PRINCIPLE DESIGN DEVELOPMENT

JEFFREY BELL ARCHITECTS
Jeffrey Bell Architects
3 Cobourg Street
off Fairfield Street
Manchester
M1 3GY

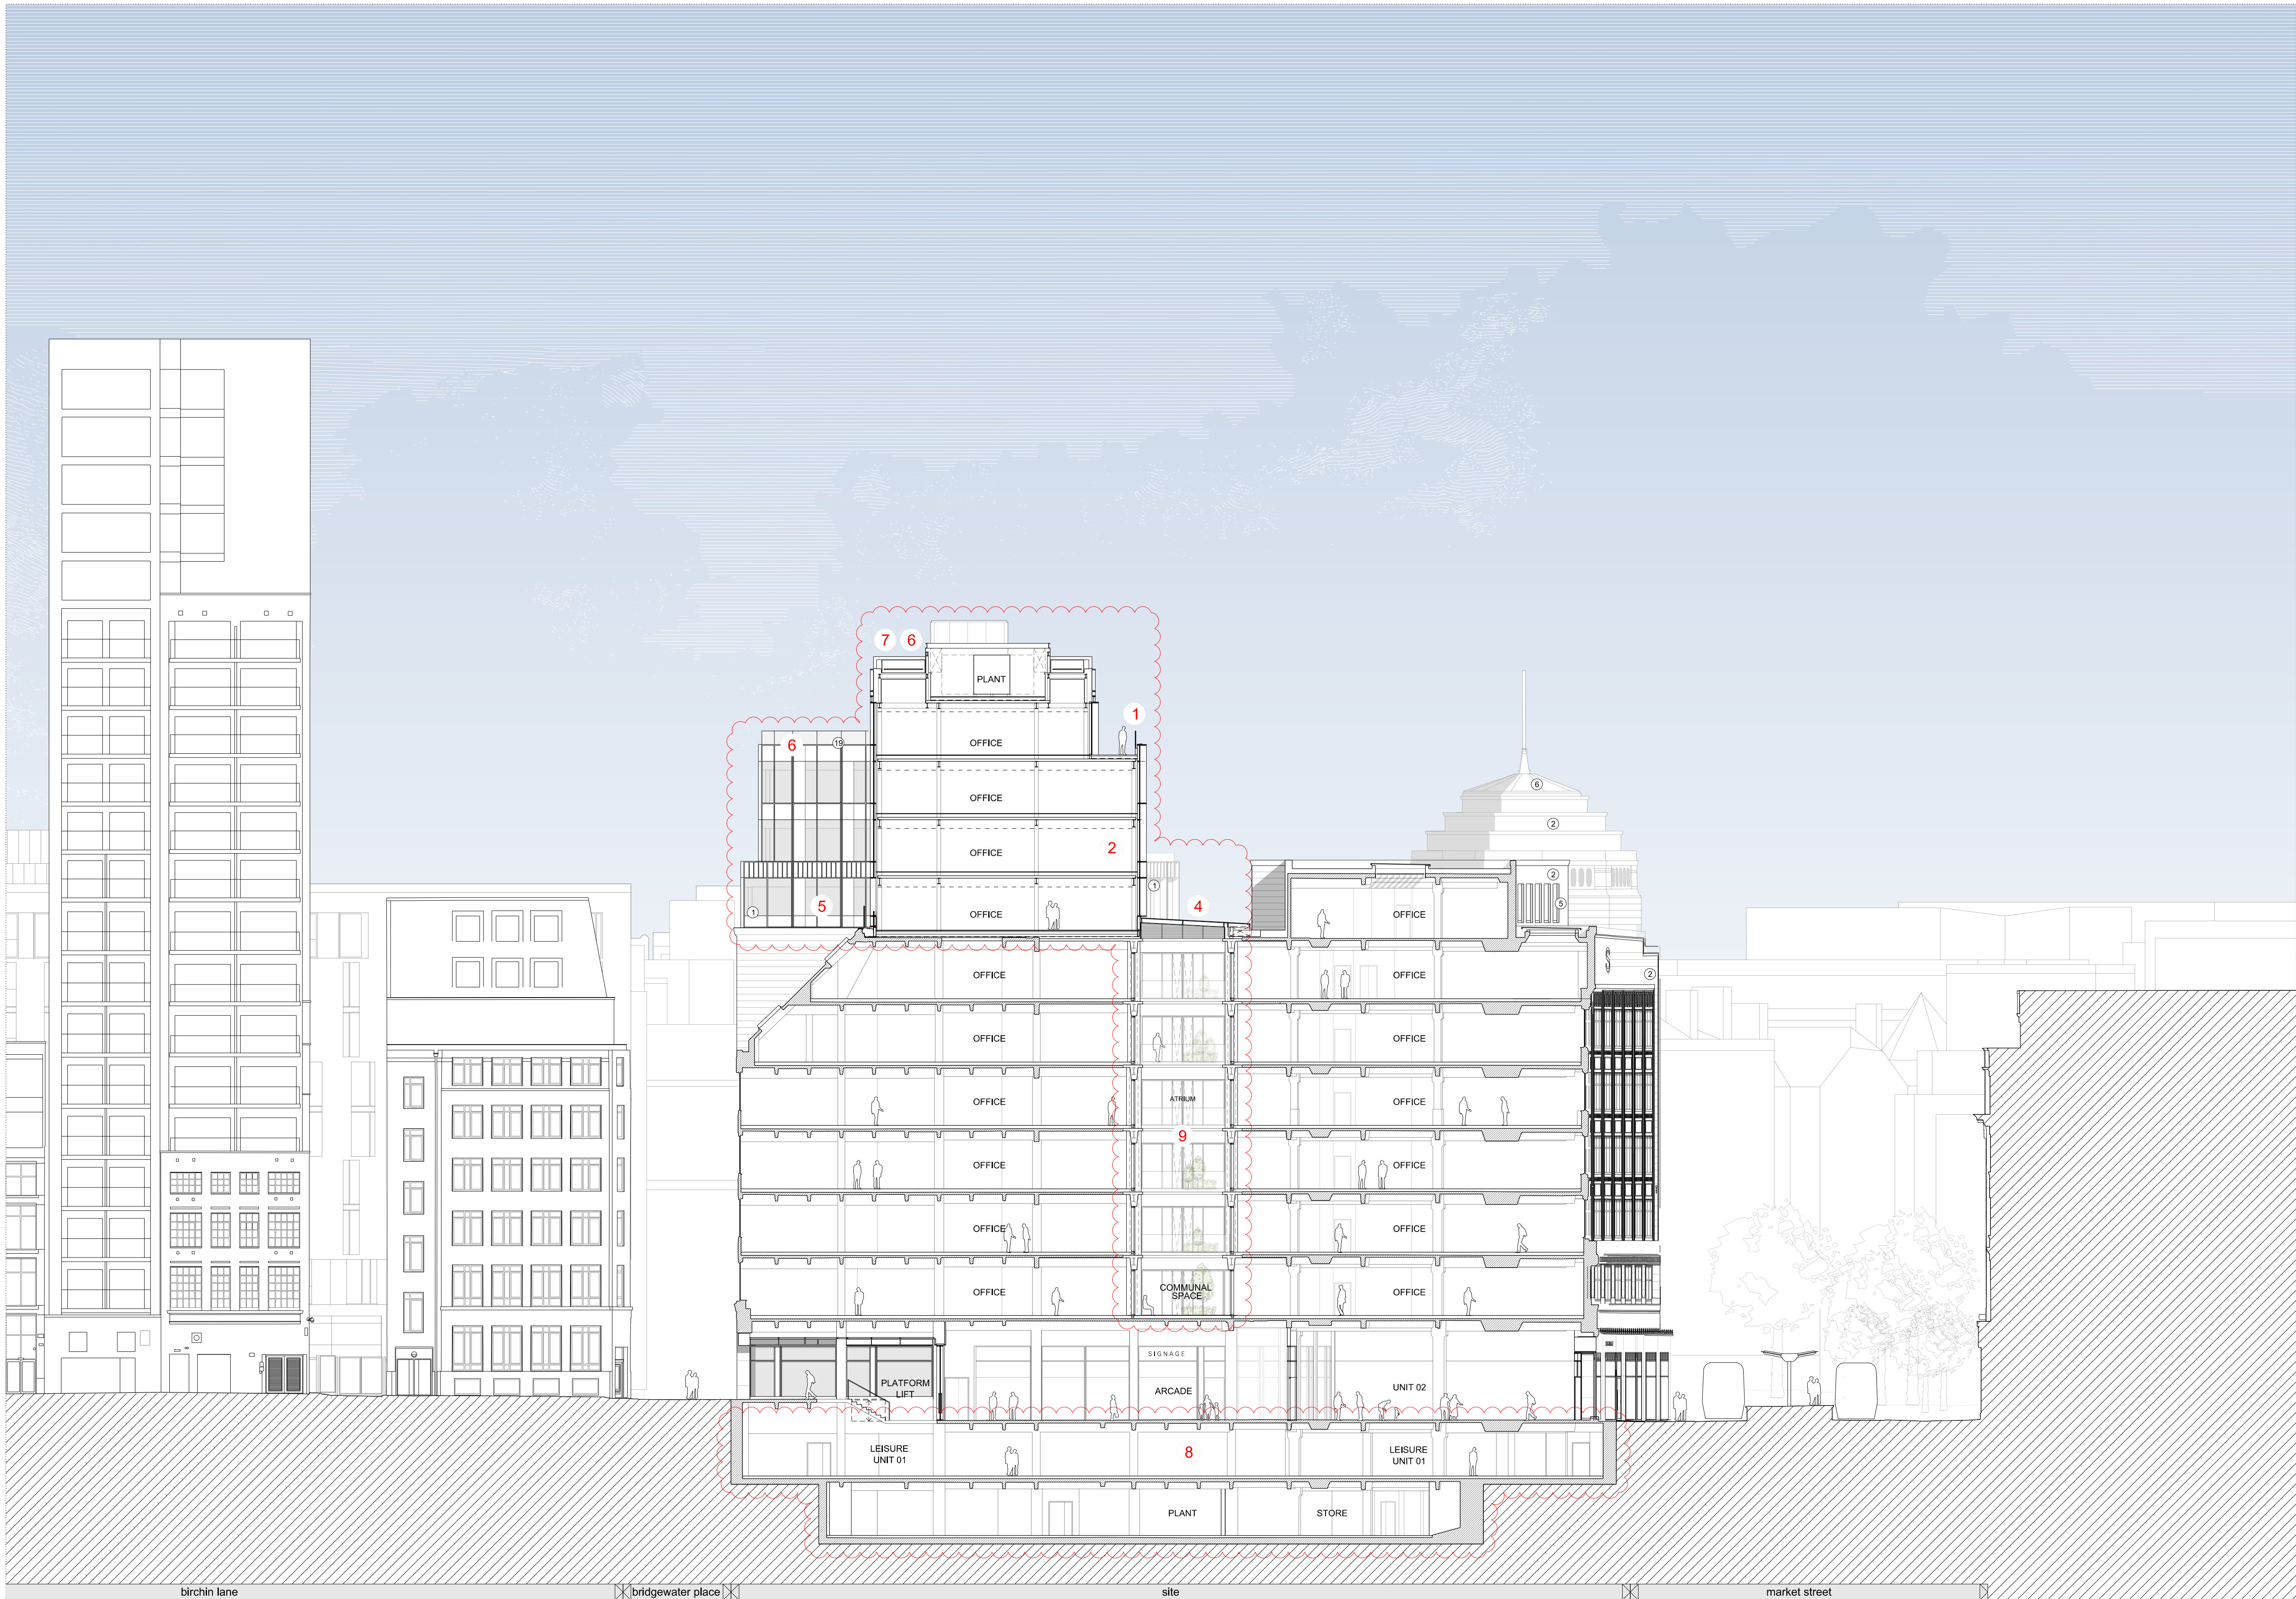
| 1. Creation of a south facing terrace to respond to change in plan form below and mitigate increase in building height. | 3. Amended form of south east level 07 elevation to respond to change in plan form. | 5. Rationalisation of the extension facade to improve buildability and building thermal performance. | 7. Overall height of the development, and massing to High Street and Bridgewater Place, remains unchanged from the consented scheme. | 9. Atrium width reduced to decrease structural intervention and increase retention of historic structure. |
| 2. South elevation responding to reduced atrium width below, aligning with existing building grid to reduce structural intervention and increase lettable area. | 4. Atrium roof simplified to improve buildability. | 6. Minor variation in external terrace and eaves heights to facilitate buildability of the new build extension. | 8. Lower floors replanned (as noted on general arrangement plans). | |
